# COMMUNITY BOARD FEEDBACK PACKAGE

**Business Name:** Grind NYC Coffee Shop

**Cafe Address:** 602 9th Avenue, New York, NY, 10036

**Application Number:** 20240618010004

## SECTION 1: Site Plan

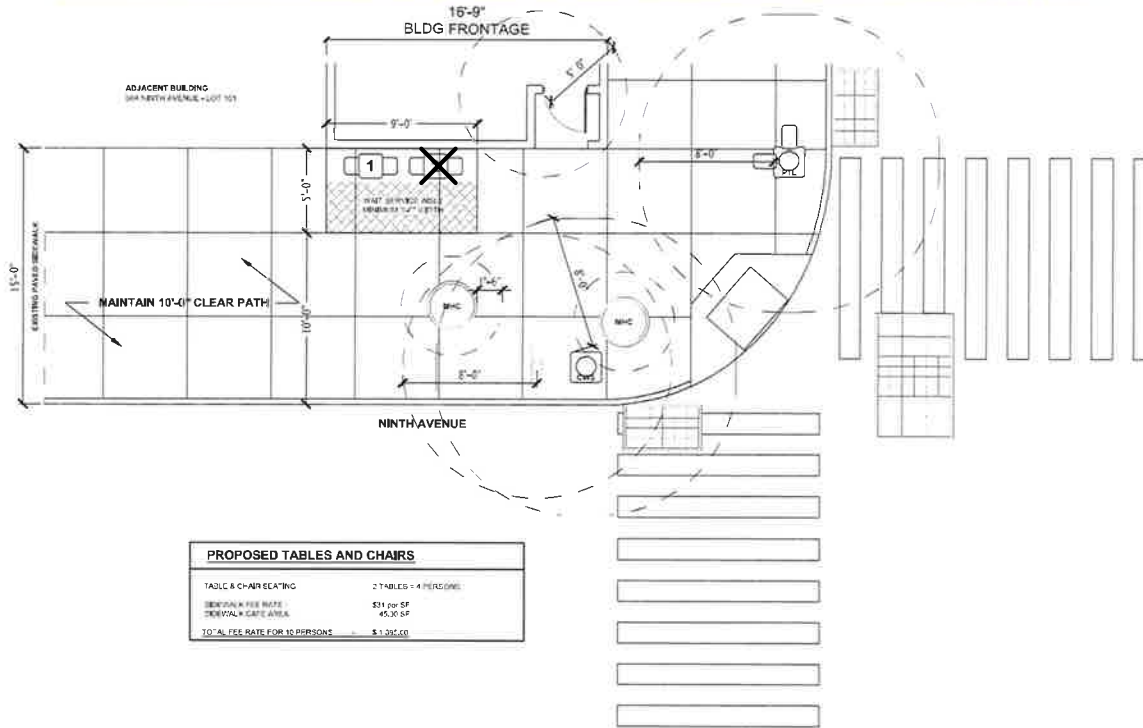
**Measurements on the original Site Plan do not accurately reflect conditions at the site. Correct measurements do not provide for the required clearances from obstructions.**

Community Board recommends **approval w/ modifications**  
Recommended modifications (**only if approved w/ modifications**):  
**To provide for the required clearances for obstructions and the 10 foot clear path, MCB4 requests that the sidewalk cafe be reduced to 4 tables 8 seats on W 43rd Street and 1 table 2 seats on 9th Avenue. The applicant agrees to these changes, which are reflected on the Revised Site Plans.**
